PLANNING COMMISSION STAFF REPORT
Meeting Date August 18, 2020

REPORT TO:	Melinda Coleman, City Manager
REPORT FROM:	Michael Martin, AICP, Assistant Community Development Director
PRESENTER:	Michael Martin, AICP, Assistant Community Development Director
AGENDA ITEM:	Woodspring Suites, 1744 County Road D East a. Planned Unit Development and Lot Division Resolution b. Design Review and Comprehensive Sign Plan Resolution

PROJECT: **Woodspring Suites Hotel – 1744 County Road D**

COMMENTS BY: **Jon Jarosch, Assistant City Engineer**

Sheet Title
SITE PLAN

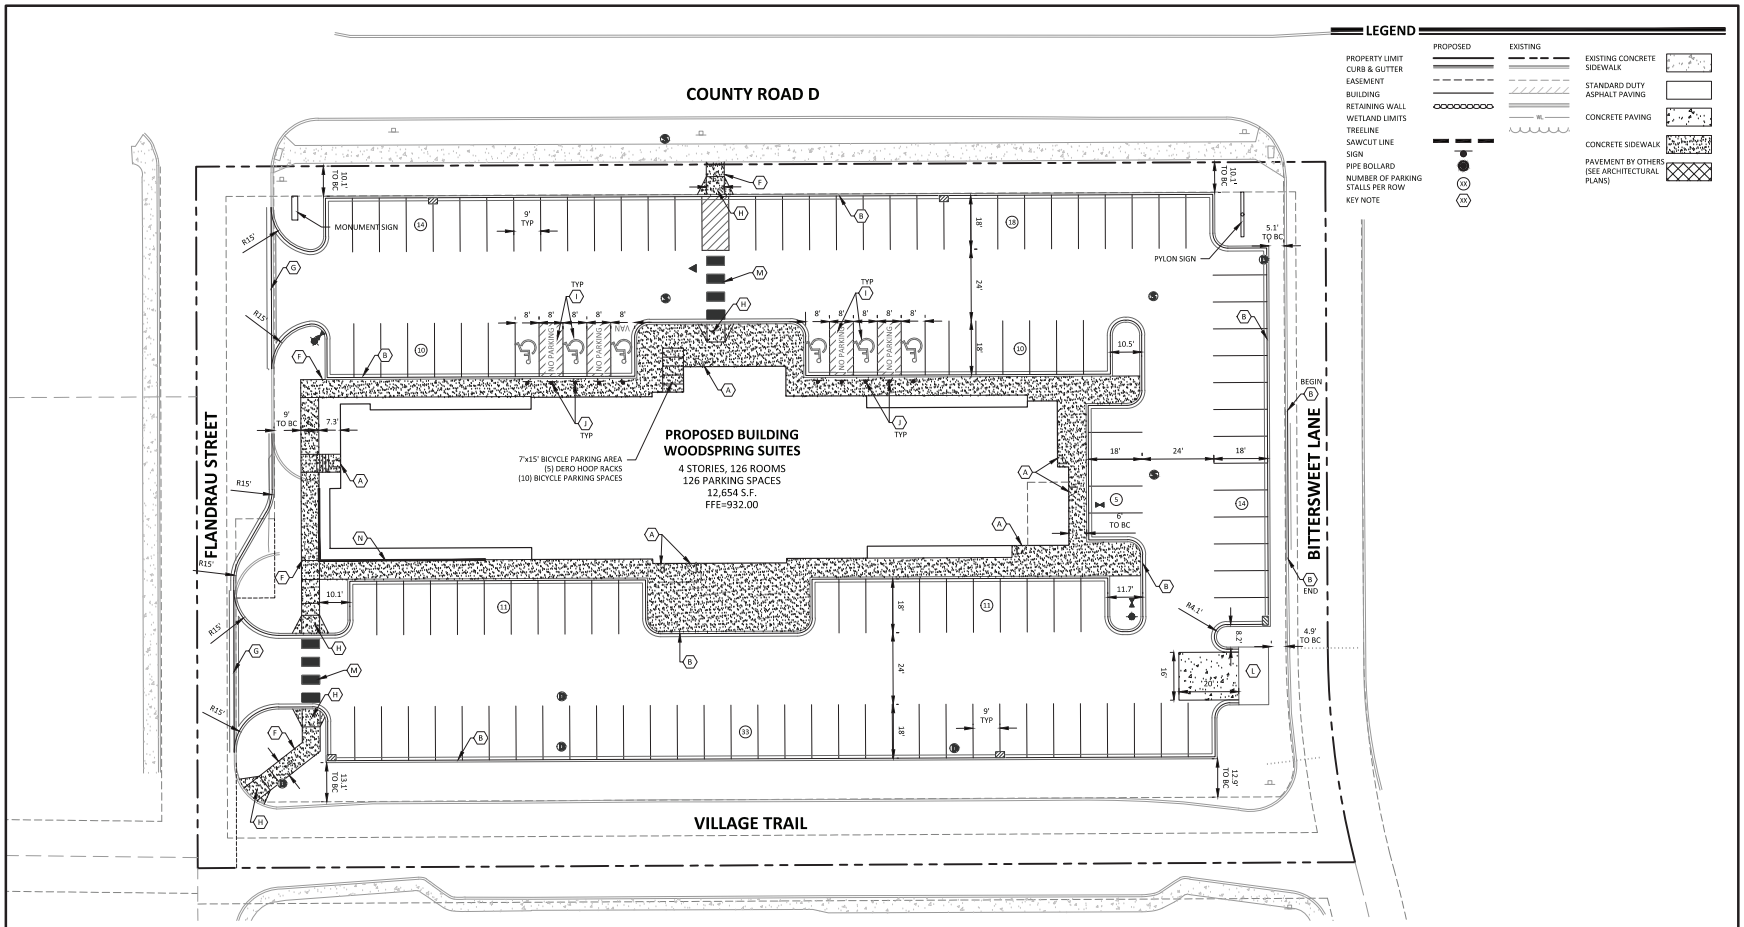
Parking lots are required to be setback 15 feet from all public right-of-way lines and five feet from all over property lines. The applicant's site plan meets this requirement on the west, east and south property lines but is only setback 10 feet from the County Road D East property line. The applicant will be required to submit a revised site plan showing the 15-foot parking lot setback being met on the north side of the site plan.

The applicant's site plan shows a connection to the existing sidewalk along County Road D East and a partial sidewalk on the west side of the building. In keeping with the rest of the Legacy PUD, the applicant shall be required to install a sidewalk along the south property line and complete the sidewalk segment along the entire west property line. A sidewalk shall also be required along the easterly frontage (Bittersweet Lane) unless the width of the site does not allow space for a sidewalk in this location. The Applicant shall work with the City during the permitting process to exhaust all options for site revisions to accommodate a sidewalk along this frontage before this requirement may be negated.

19) Keeping in spirit with the remainder of the Legacy PUD, sidewalks shall be added along all street frontages. The existing site plan shows the existing sidewalk along the north frontage (County Road D) and a proposed sidewalk along a portion of the west frontage (Flandrau Street). The sidewalk shall be extended the complete length of the westerly frontage. A sidewalk shall also be added along the southerly frontage (Village Trail).

a. Revised site plan showing the parking lot front yard setback of 15 feet being met.

Sheet Title
LANDSCAPE PLAN

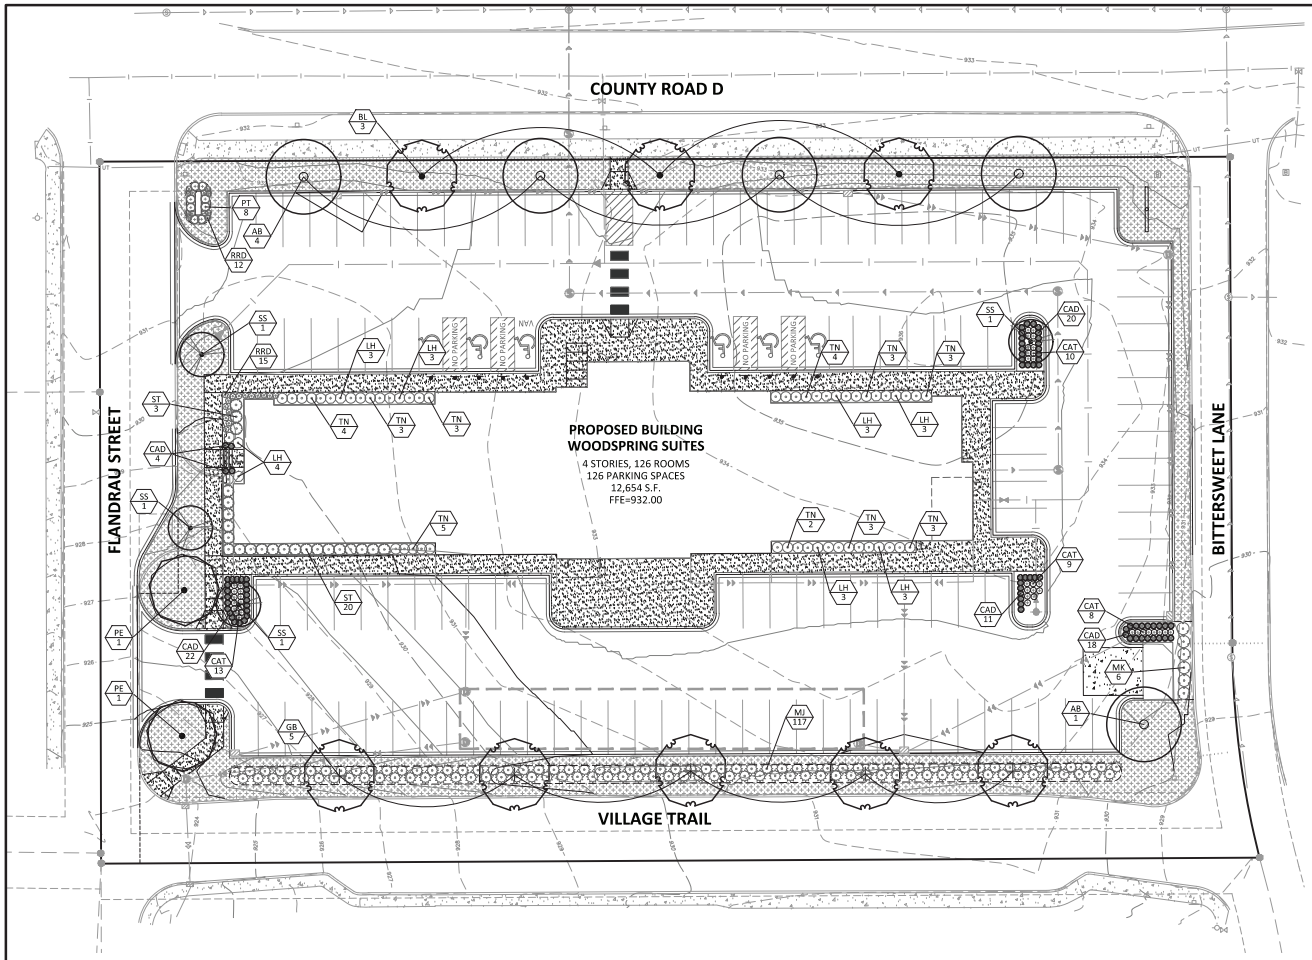
There are no significant trees on the site. The applicant is proposing to plant a total of 19 trees. Fifteen 2.5 caliper inch deciduous and four 2 caliper inch ornamental trees. There is approximately 364 feet of greenspace along Village Trail. Seven trees are proposed within this green space. To meet the PUD overstory tree requirement the applicant must install at least 9 trees that are 40 feet on center along the Village Trail greenspace. The rest of the site meets the City's tree preservation ordinance.

b. Revised landscaping plan showing at least nine trees being planted along Village Trail as required per this site's planned unit development.
